PLANNING PERMIT APPLICATION REFERRAL

PLN2006-00494

PROJECT LOCATION: 8150 CARRILLO HWY

Use Permit Amendment to:

L-1

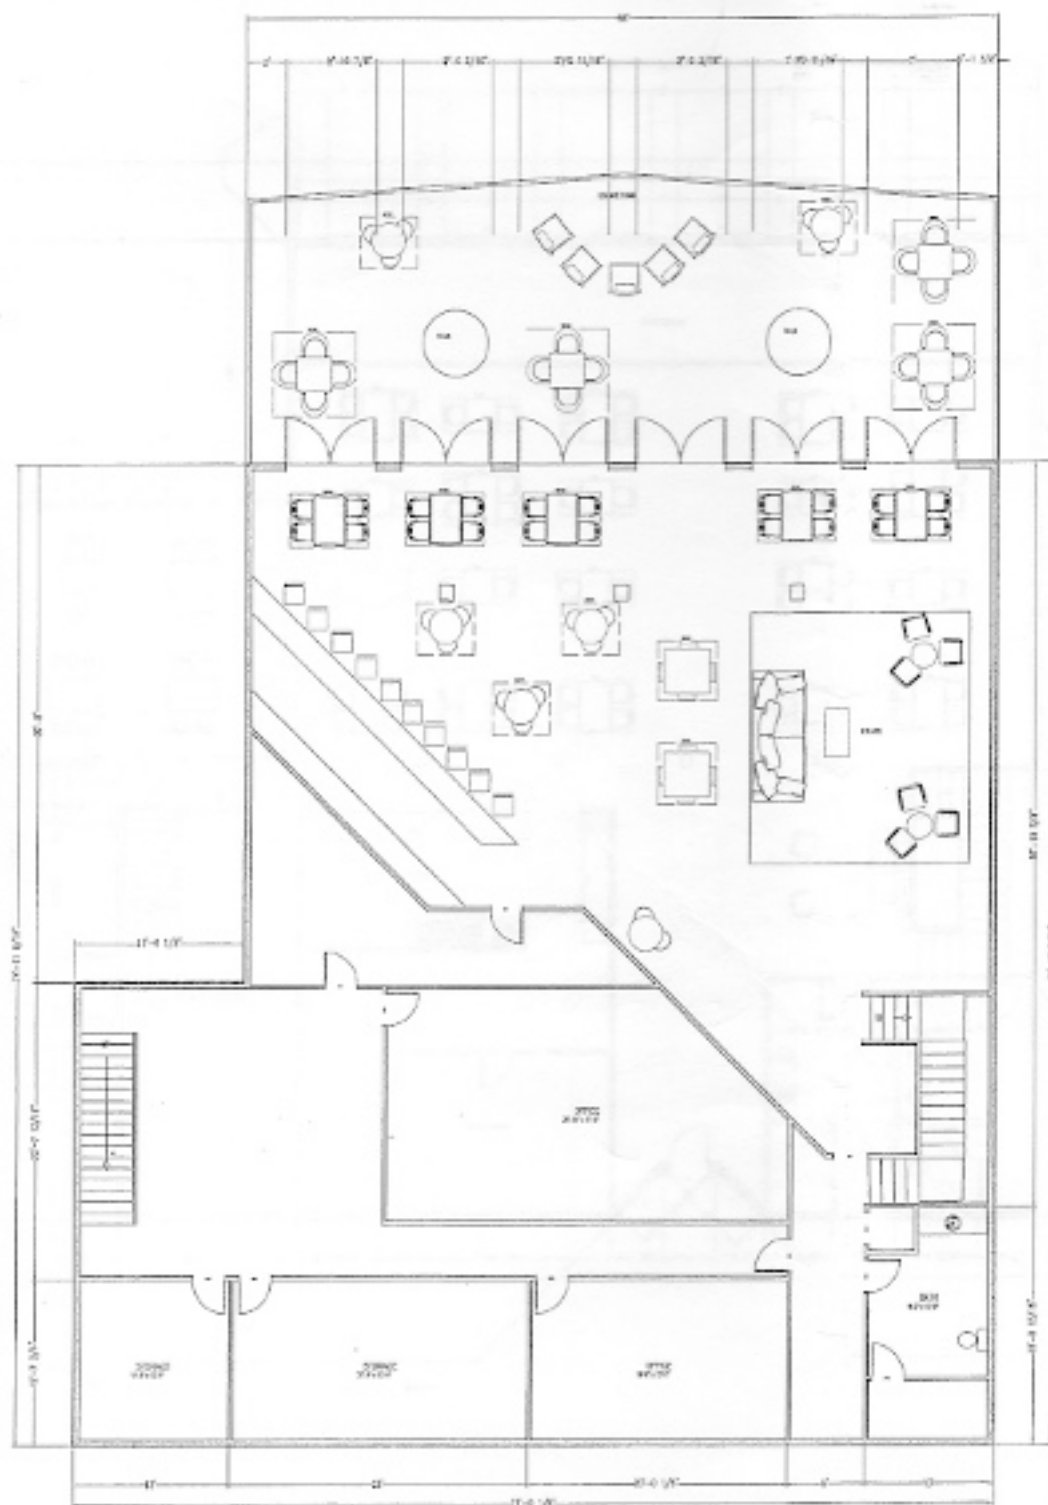
Landscape Architecture: Please replace *Echium fastuosum* (Pride-of-Madeira) with a non-invasive plant species. According to the California Invasive Plant Council, "Pride-of-Madeira is a common landscape ornamental requiring a summer source of moisture in inland areas but can escape cultivation in coastal regions. Little is known about the biology or invasiveness of Pride-of-Madeira, but it appears to spread slowly into established native plant communities."

2. The Landscaping Plan appears to include new landscaping with a variety of non-native species on State Park property. The General Plan for Montara State Beach provides that native species will be used for landscaping. We request that the applicant consult with State Parks on appropriate native species to use in these areas.

3. The Plant List provided in the Landscaping Plan contains species that have been shown to be invasive, including ruby grass (*Melinis* sp.) and Pride of Madeira (*Echium* sp.) We request that these species not be used adjacent to State Park property, and that any species added to this list are reviewed for their potential to spread to wild land areas. We request that the applicant consult with State Parks to develop a final plant list for the areas adjacent to State Park property.
